Marine
Management
Organisation

20 June 2022

Planning Act 2008 - Application by Ørsted Hornsea Project Four (UK) Limited (“Ltd”) for an Order Granting Development Consent for Hornsea Project Four Offshore Wind Farm

Deadline 5 Submission

Figure 1- Based on Figure 6 (bottom panel) from the supplementary report (1979-2020/1). An additional red dashed line has been added showing the geomorphological eastern boundary of Smithic Bank.

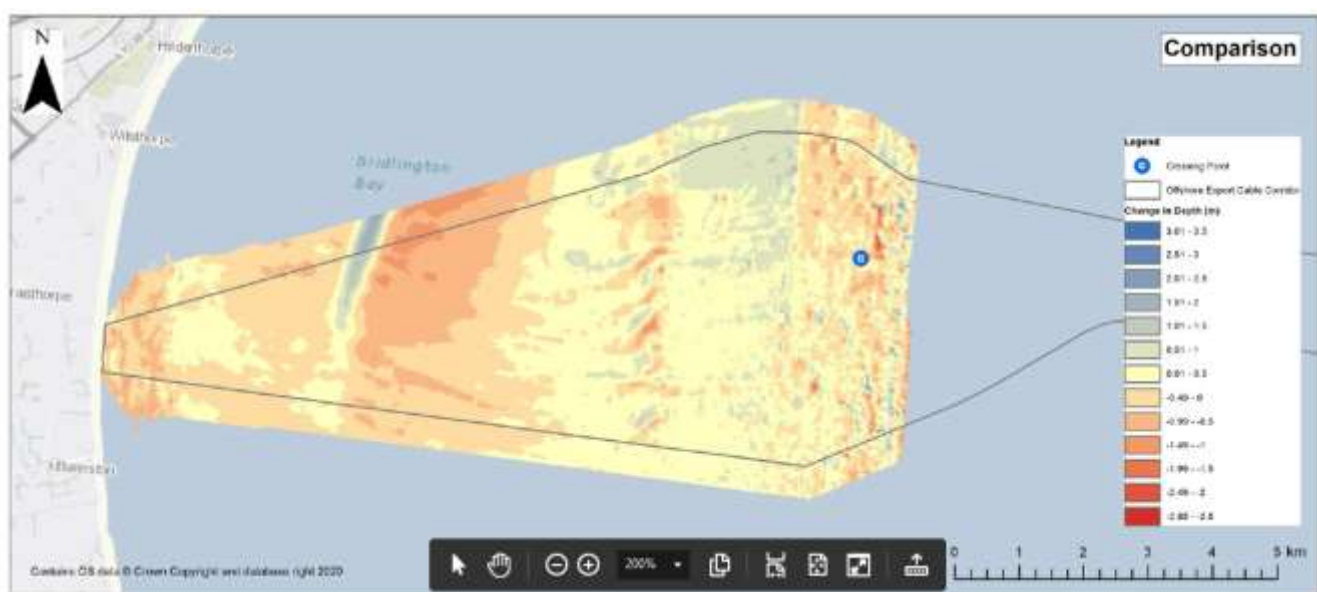
4.1.5. In section 2.4.5.2 the impacts of the cable on the bank are considered to be “*negligible and remain local to the infrastructure*”. This is key to the concerns about Smithic bank. In Figure 1 of this submission (based on Figure 6 of the report) show that whilst on the flanks of the bank significant changes of up to 2.5m have been observed between 1979 and 2020/21. Furthermore, if the location of the rock berms identified in Figure 2 of this submission are added to this plot the distance to the geomorphological boundary (red line) is considerably smaller. In summary, the final planned position of the Dogger A and B export cables, should be overlain on Figure 1 (this submission) with the planned berm positions and Hornsea 4 cable routes from Figure 2 (this submission) along with the geomorphological boundary (dashed red line). Once completed, the interaction (or not) between these structures will become more apparent.

Figure 2 - Based on document (5). Note That the green Dogger bank A and B are order limits are for 2 bundles of 2 cables each. Therefore, the six Hornsea 4 cables would cross the 2 trenches of Dogger A+B producing twelve rock berms/crossing points.

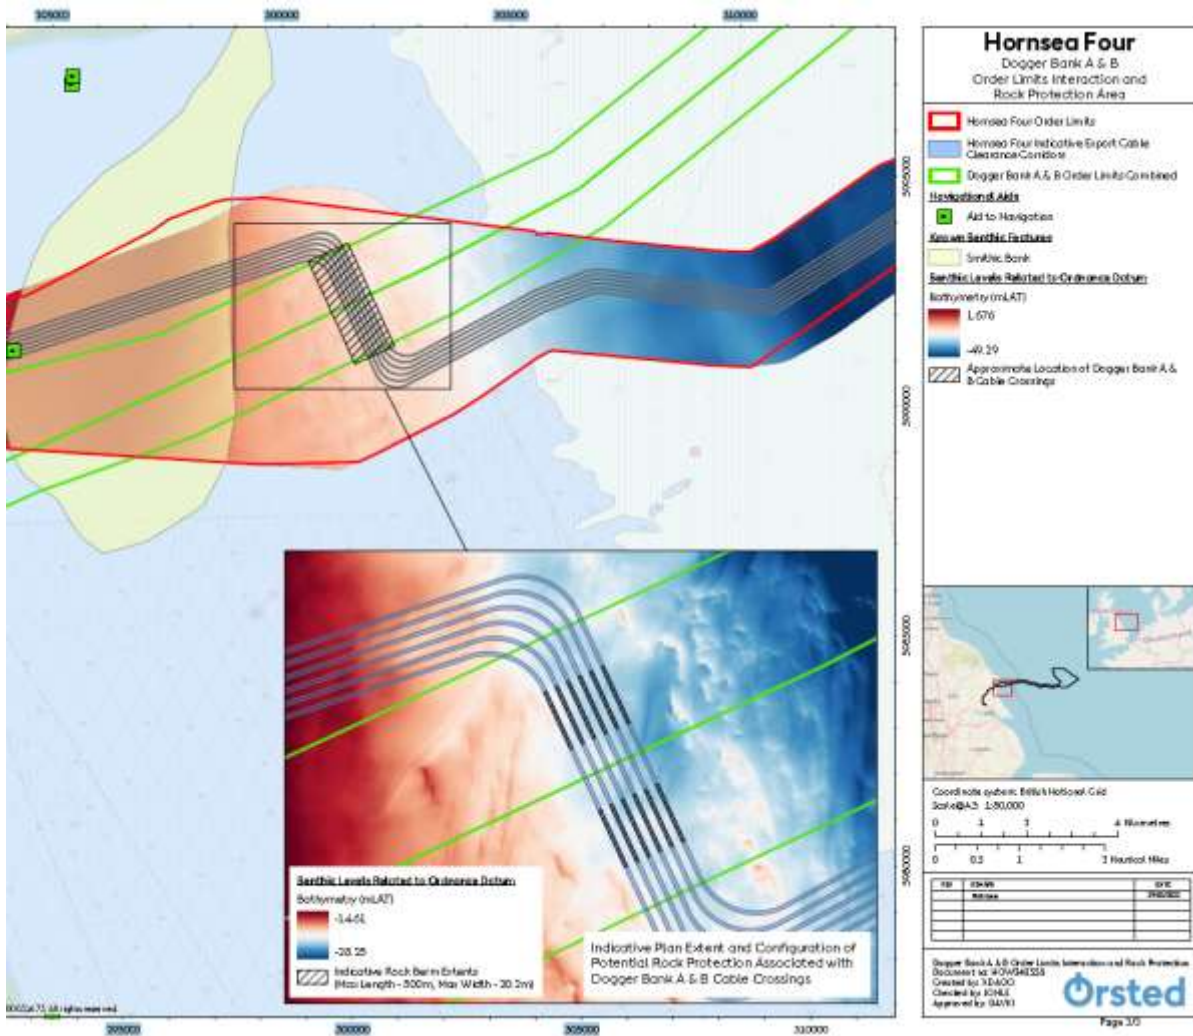
- 4.1.8. Furthermore, the cumulative impact of the Scotland-England Green Link needs to be assessed especially as it passes over Smithic Bank.
- 4.1.9. The MMO requests that the following mitigation/monitoring options are considered:

- Moving the crossing further east would reduce any residual impacts on Smithic Bank.
 - Whilst it's normal industry practice to cross at 90 degrees, could an exception be agreed so that the whole crossing envelope is moved further east?

- A commitment to zero scour protection with the 20m contour would de-risk impacts on sediment transport.
- 4.1.10. **Flamborough Front**
Summarising the issue, the mixing from the Gravity Based Structure and Monopiles will mix cold, high nutrient bottom waters through the water column to the surface.

Figure 3 - Sediment transport vectors based on a Rare Earth elements tracer study based on their Figure EX1 (Pye, Blott, Pye, 2015).

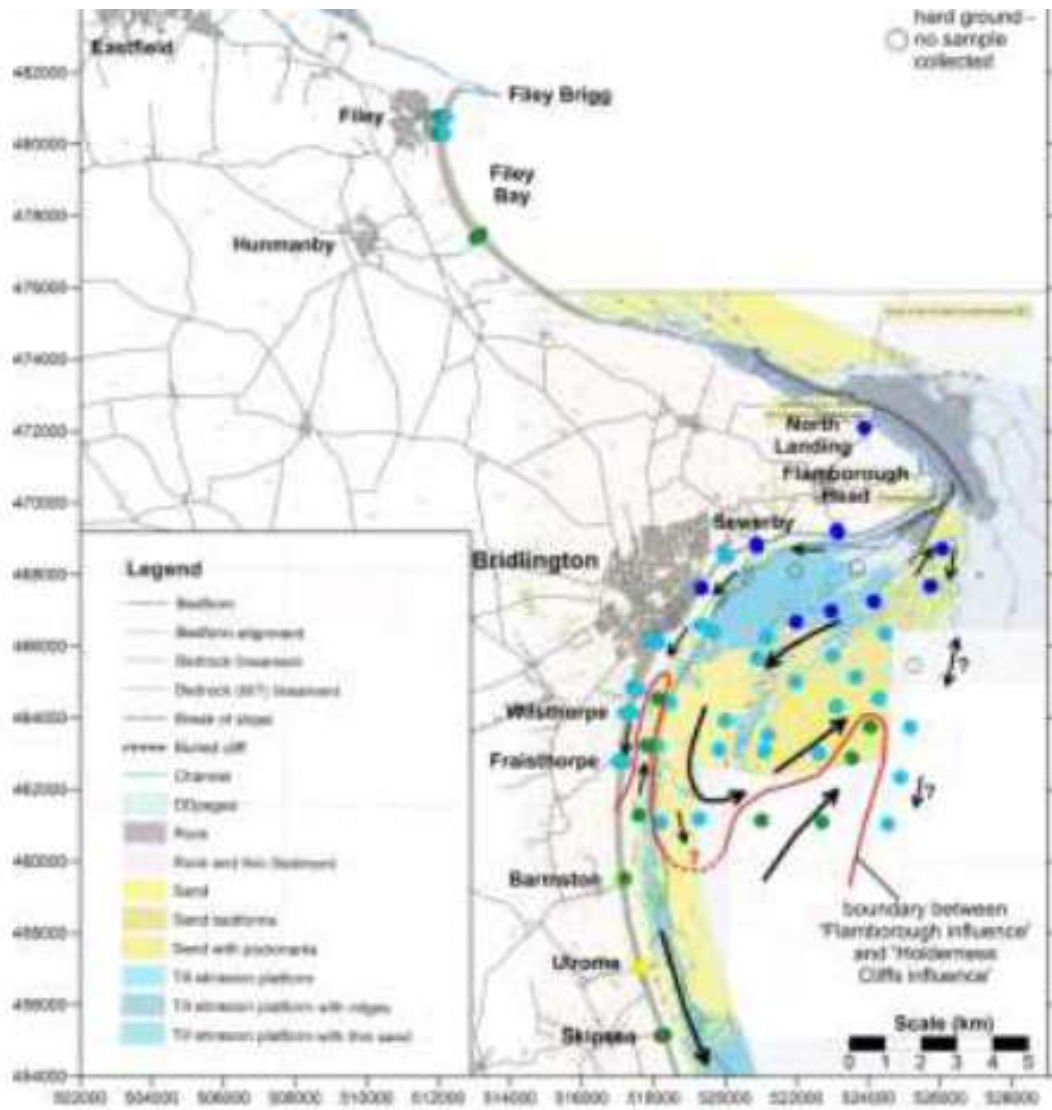
4.1.6. Figure 6 of the report (document 4) also introduces the blue line of sources of sediment from the preeminent authors of Pye, Blott and Pye (2015). Using a technique based on rare earth elements (REE) they infer the source of the sediment and therefore the sediment transport direction (see Figure 3 of this submission). They split this into two sources, the Holderness, and Flamborough coasts and infer transport along gradients. Whilst they agree with the clockwise circulation of North Smithic, the data suggests an anti-clockwise circulation of the main Smithic bank. Two issues arise out of this. Firstly, how does the Applicant reconcile the evidence from swath bathymetry represent in this report of a west and North West movement against the anti-clockwise circulation in Pye, Blott and Pye (2015). Secondly, northerly transport near to the coast could be considered to isolate Smithic from the coast (except for the frontage directly opposite the town of Bridlington). Can Smithic Bank be considered to be closed

or at least semi enclosed and thus not the “dynamic reservoir” that was recently considered to be the most likely sources of sediments along the Holderness coastline?

Figure 4 - 1794 chart of Bridlington bay showing Smithic Bank
 (https://www.usna.edu/Users/oceano/pguth/website/shipwrecks/logbooks_lesson/logbooks_lesson.htm)

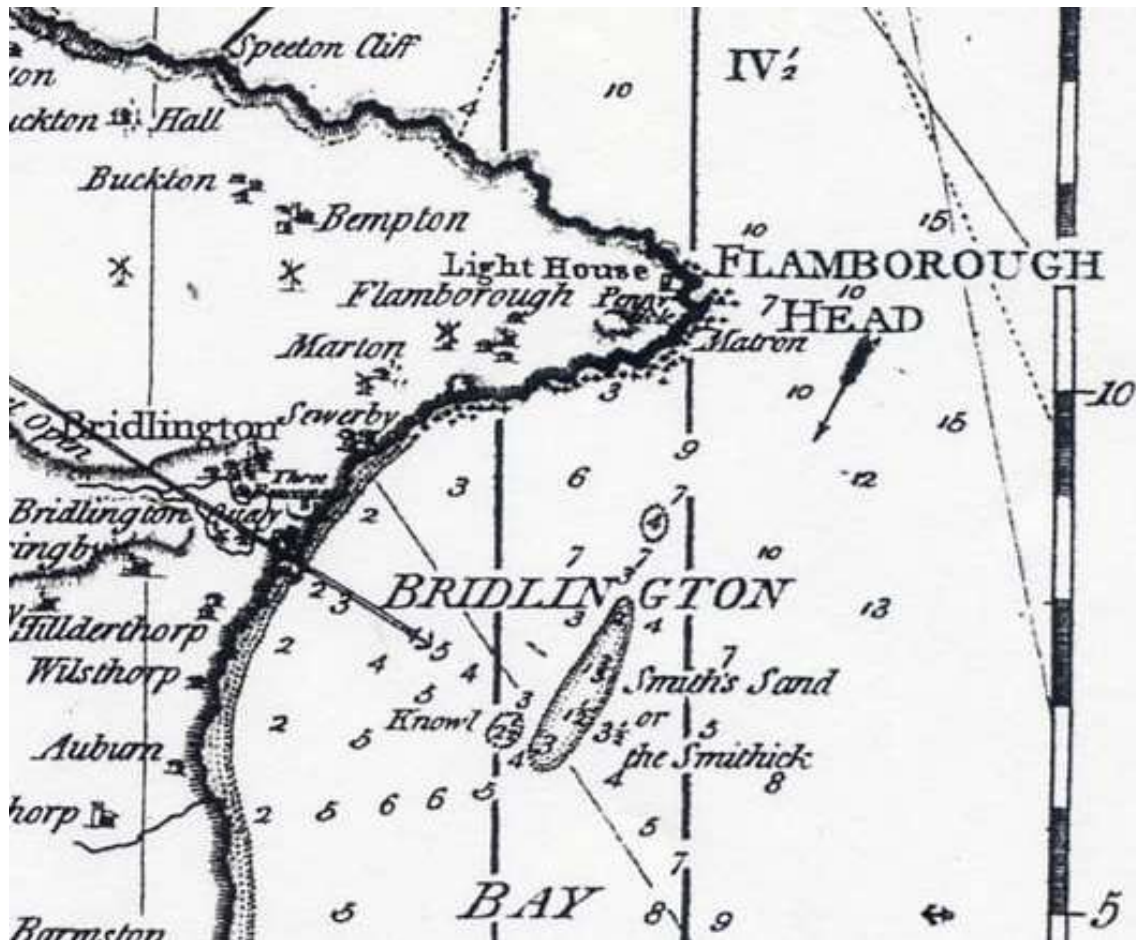
- 4.1.7. In section 2.4.2.2 The authors recognise that Smithic Bank has reduced in height from 1979 to 2020/21. Is this a long natural trend e.g. driven by sea-level rise or changing wave climate) or a cyclical process and just reworking of the sediments? For instance, the 1794 chart (https://www.usna.edu/Users/oceano/pguth/website/shipwrecks/logbooks_lesson/logbooks_lesson.htm, shown in Figure 4 of this submission) shows Smithic in a similar position but with shallower depths (note depths in Fathoms).

Figure 1. Comparison of 1979-2020/21 bathymetric survey data (taken from Ørsted, 2022)

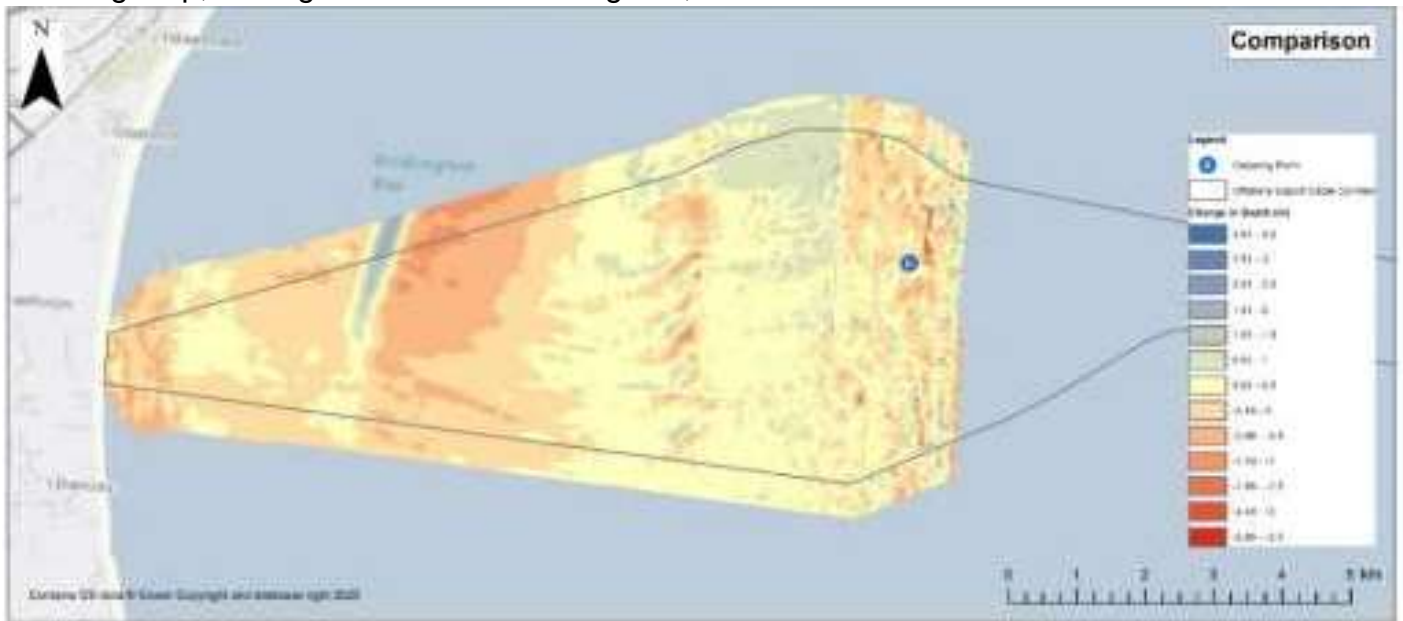
Figure 1 above shows comparison of the 1979 and 2020/21 bathymetric data for the Dogger Bank A & B Cable Crossing. This shows that there is evidence for up to 2.5m bathymetric change at the Dogger Bank A & B Cable Crossing site over the period 1979-2020/21 which raises concerns regarding the potential for morphological change.

Figure 2. Dogger Bank A & B Export Cable Crossing Rock Protection (adapted from Ørsted, 2022).

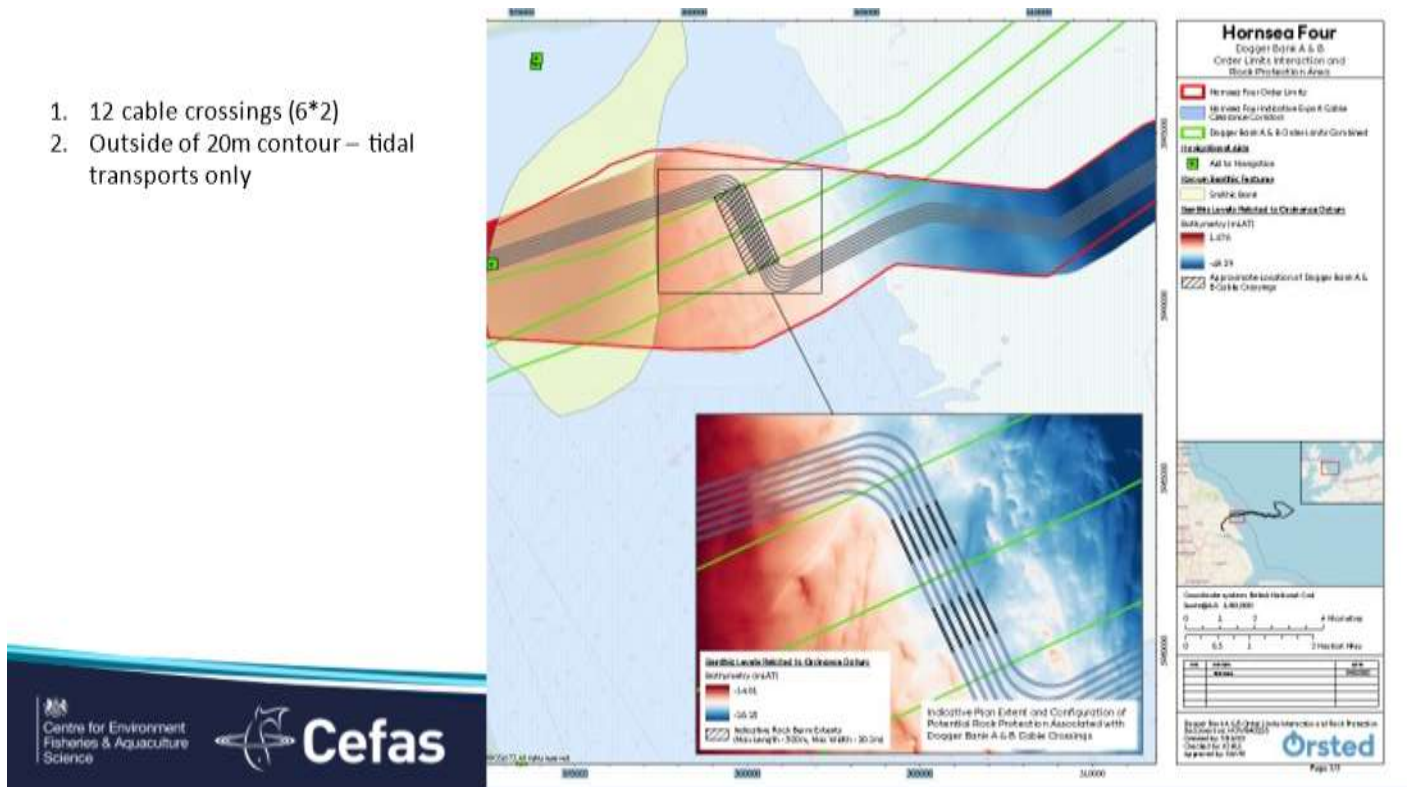
Figure 2 below shows the Hornsea Four/Dogger Bank A & B Order Limits Interaction and rock protection area. The Dogger Bank A & B Cable Crossing includes 12 cable crossings with individual rock berms at each cable crossing that have maximum length and width of approximately 500m by 20.2m, and a berm height of up to 3m. Given the close proximity of the Dogger Bank A & B Cable Crossing to the geomorphological eastern boundary of Smithic Bank, we remain concerned that the presence of these cable protection measures could cause morphological change (e.g. enhanced lowering of the sandbank) through the modification of the hydrodynamic regime or via diversion of sediment transport pathways and, therefore, we advise that the cable crossing be moved as far seawards as possible within the Order Limits. Whilst noting the constraints Orsted face with regards to moving the cable crossing eastwards due to the Order Limits, Natural England and MMO/CEFAS also propose that any reduction in the MDS of cabling and crossings which could be secured before consent would also help limit any impact on the Bank, such as bundling Hornsea 4 cables within fewer trenches and using HVDC technology to reduce the total number of cables and crossings required. It is also worth noting that Dogger Bank A&B has confirmed that their export cables will be bundled in 2 trenches.

Given the indicative nature of the current Hornsea Four plans showing the location of the Dogger Bank A & B Cable Crossing, we advise that the most up-to-date Dogger Bank A & B cable routing plans should be used to generate more accurate cable crossing plans by the Applicant. In turn, this more up-to-date and accurate plan of the Dogger Bank A & B Cable Crossing will provide a clearer indication of the location of the crossing relative to the eastern geomorphological boundary of Smithic Bank and inform the impact assessment.
